## MEMORANDUM TO THE LANDMARKS BOARD

September 9<sup>th</sup>, 2020

### Landmark Alteration Certificate Request

Address: 2130 11<sup>th</sup> Street.  
Owner: Kari Whitman  
Applicant: Ethan Hampton, Hampton Architecture  
Case Number: HIS2019-00374  
Case Type: Landmark Alteration Certificate  
Code Section: 9-11-18, B.R.C., 1981

Figure 9. Existing & Proposed West Elevation (façade). Not to scale.

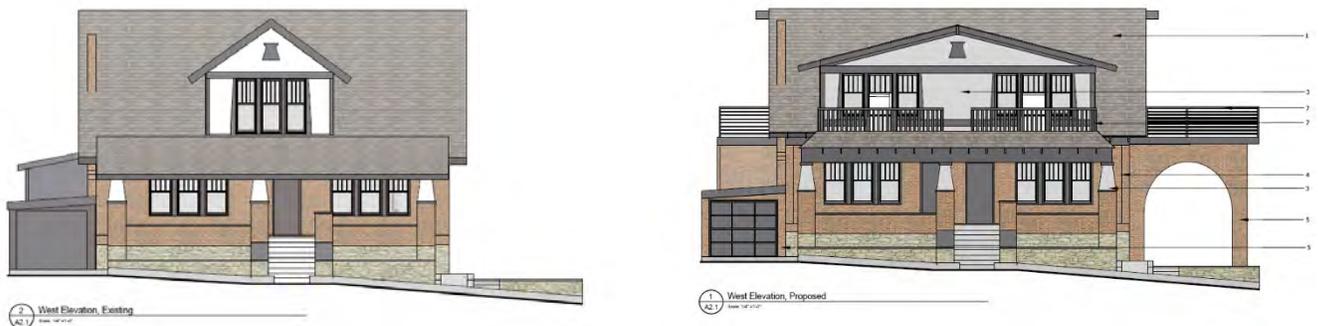
## West Elevation (Façade)

- Removal of front dormer and construction of wider dormer to accommodate six 3/1 double-hung sash to match existing historic windows;
- Removal of front shed roof porch and construction of hipped roof form to provide two upper-story deck area enclosed by vertical railing;
- Removal of stone garage at north and construction of brick garage, and removal of rear frame shed-roof addition with flat-roof brick addition with roof deck;
- Construction of round brick-arch carport at south side of house with roof-top deck enclosed by horizontal rail.

The existing gable dormer on the façade of the house is character-defining and should not be altered – the proposed new dormer and alteration to the historic shed porch roof will have a significant impact on the historic character of the house. Likewise, the proposed new rear dormer should be reduced in height and scale. Proposed flat roofs to accommodate roof decks are not found on the historic house. Modifications shortening eave depths on a historic house are inconsistent with this section.

Proposed front roof deck will significantly change the character of the front porch roof from shed to flat with hip skirts.

Dominant roofline of west facing historic character defining dormer will be altered by proposed new dormer which is wider with significantly lower roof pitch. Likewise, shed roof form of character-defining front porch is changed to flat roof with hip skirt to accommodate deck, and will change the essential form and character of the contributing house.
